**PROJECT**  
**BEDMINSTER FARMS**  
 LOTS 12, 15, AND 21 BLOCK 39  
 BEDMINSTER TOWNSHIP  
 SOMERSET COUNTY  
 NEW JERSEY

Re: Bedminster Farms  
Preliminary and Final Major Subdivision Plans  
Block 39, Lots 12, 15, & 21, 1120 & 1320 Lamington Road  
Bedminster Township, Somerset County, New Jersey

On behalf of the applicant Bedminster Farms, the Subdivision Plans and associated documents have been revised to address comments in the Township Engineer and Township Planner's review memos.

In response to the Township Engineer's review memo dated June 5, 2020, we offer the following comments.

PRIVATE ROADWAY PROFILE (PREFERRED) - STA. 0+00 TO 16+50  
 SCALE: 1"=50' (HORIZONTAL)  
 1"=10' (VERTICAL)

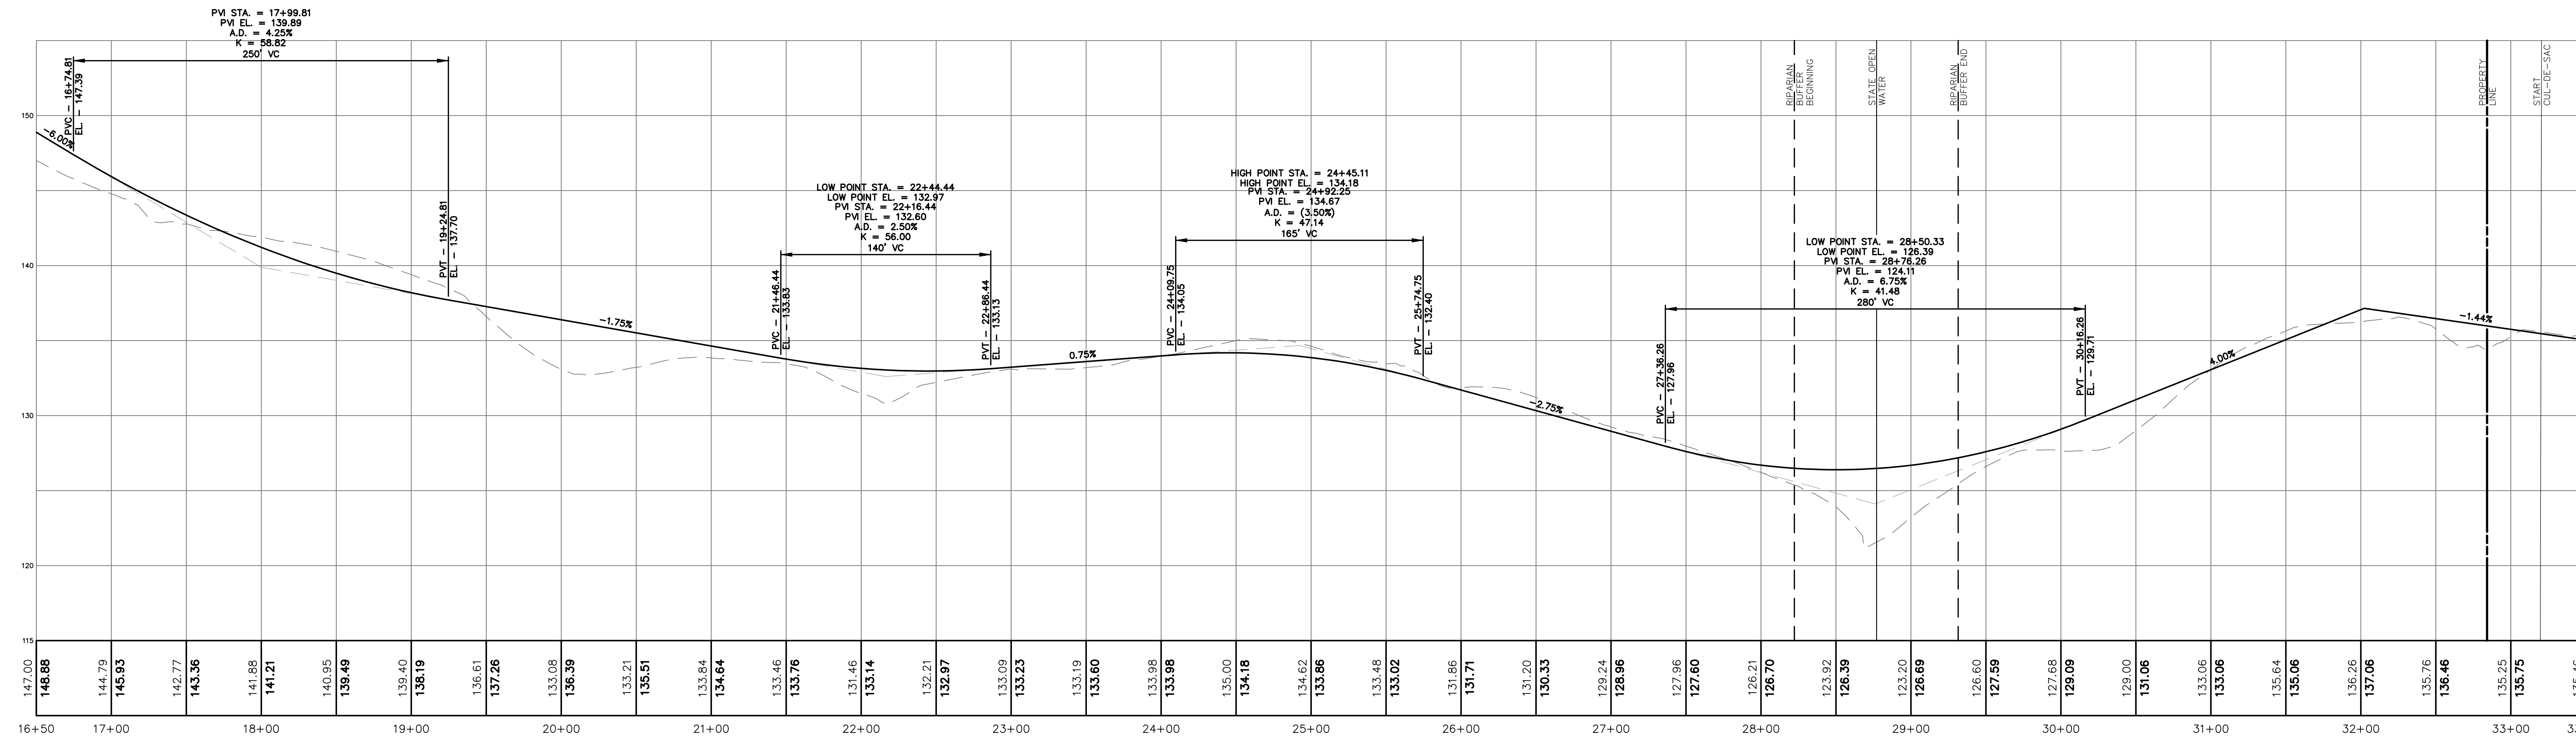
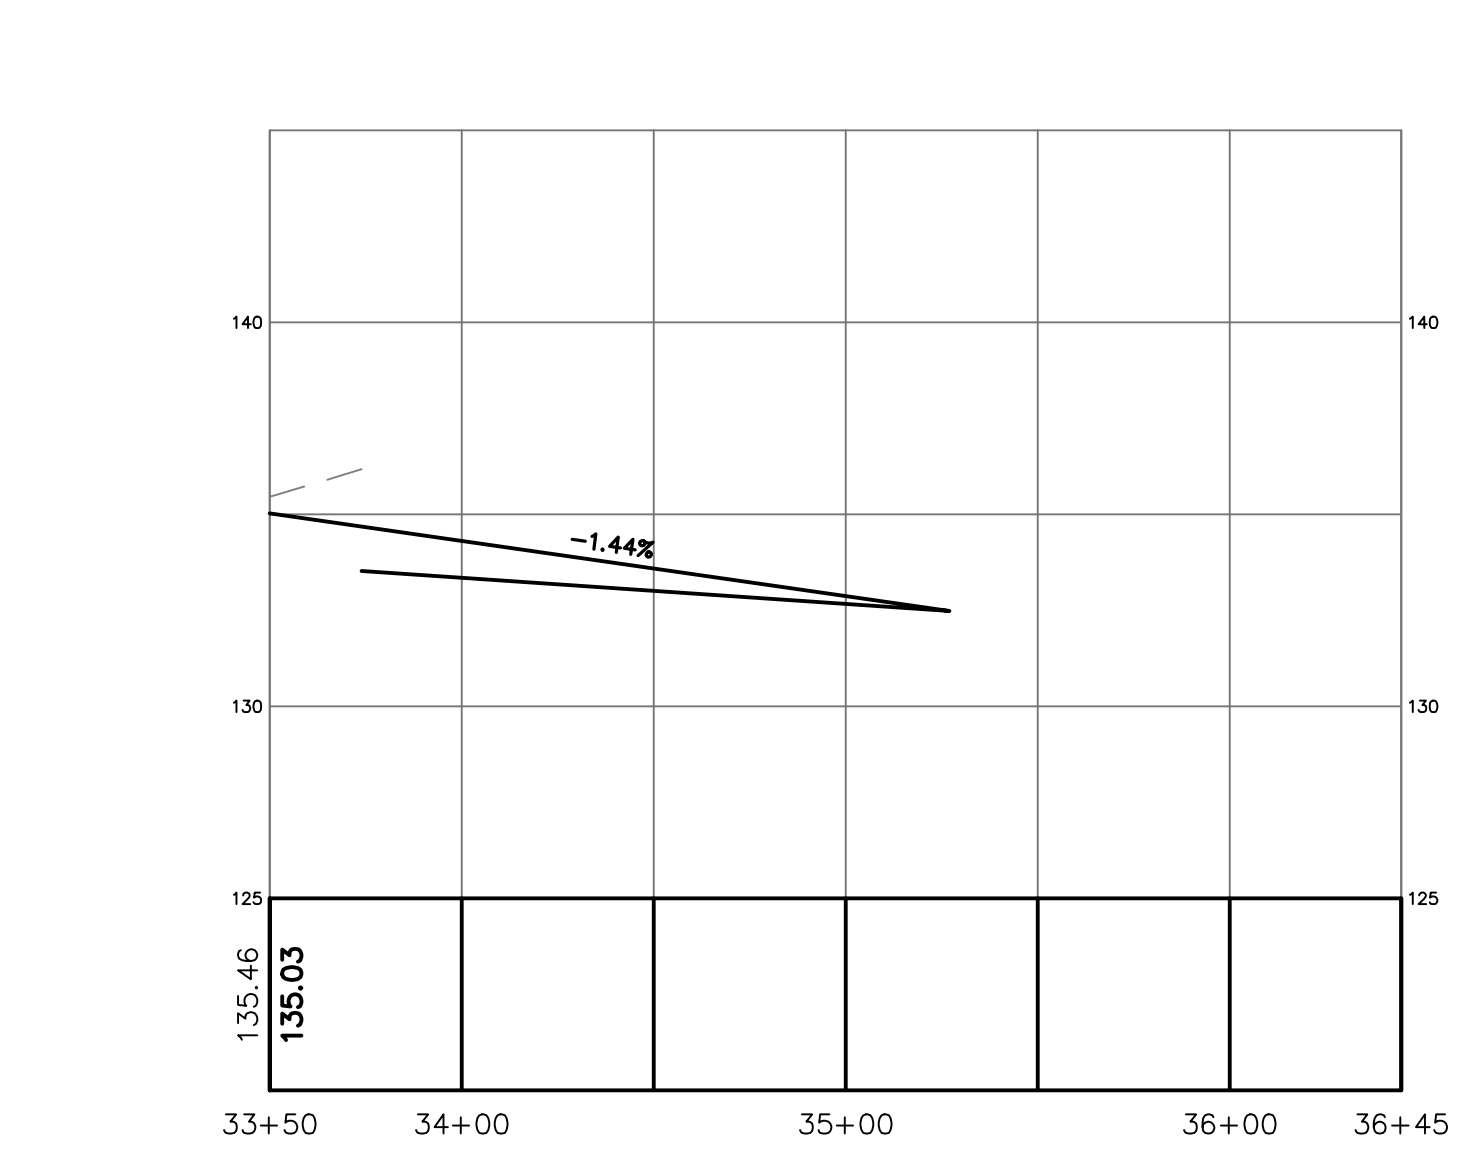
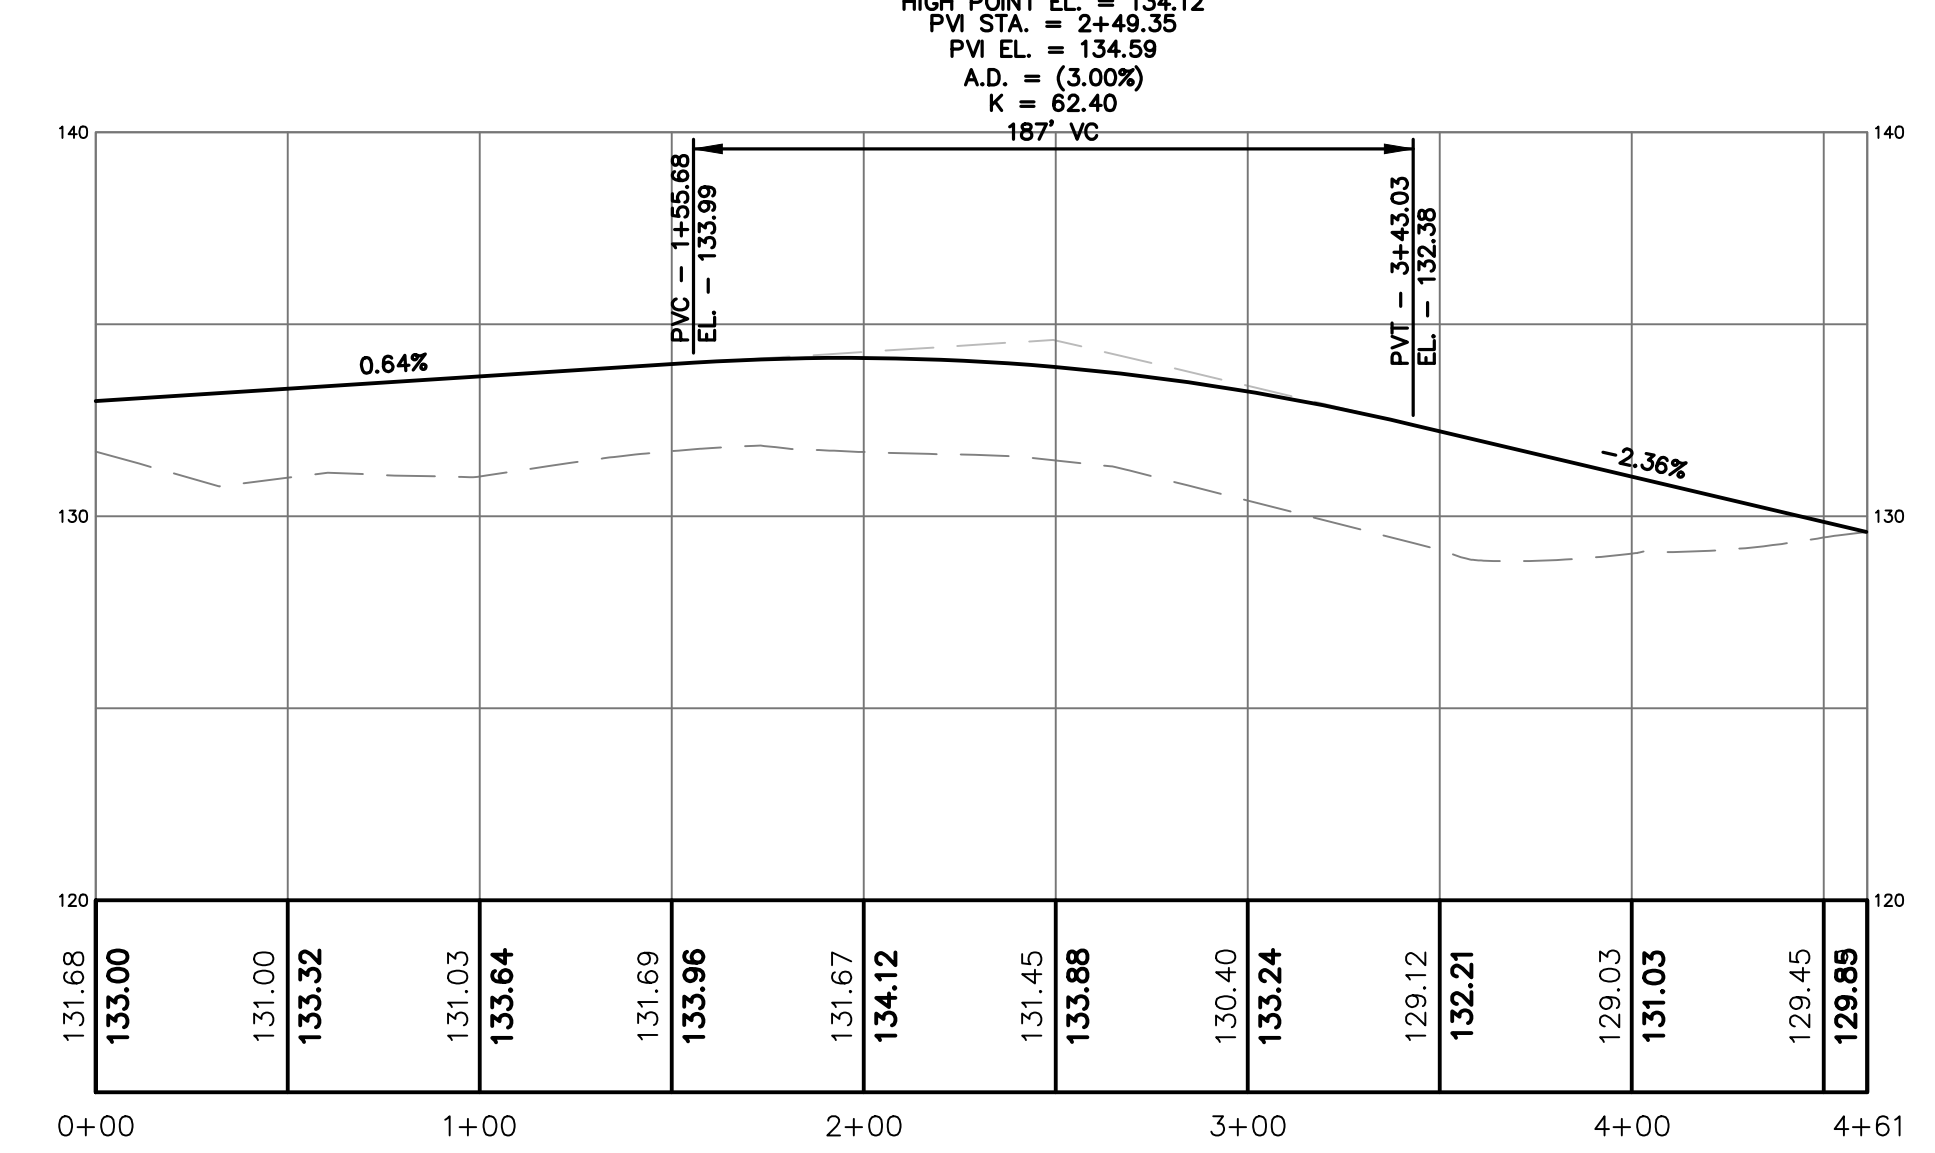
G. Sheet 12 – Driveway Profiles (Preferred Layout)

- G. Sheet 12 – Driveway Profiles (Preferred Layout)
1. The grading on the private road has been reviewed to determine the additional portions of the roadway that should be constructed with a crown. Following the review, only a portion of the roadway adjacent to the property line with Lot 21.01 was revised to include a crown. The area adjacent to Lot 21.01 was determined to not utilize a crown due to the existing drainage patterns and the desire to not put undue stormwater runoff on the adjacent property.
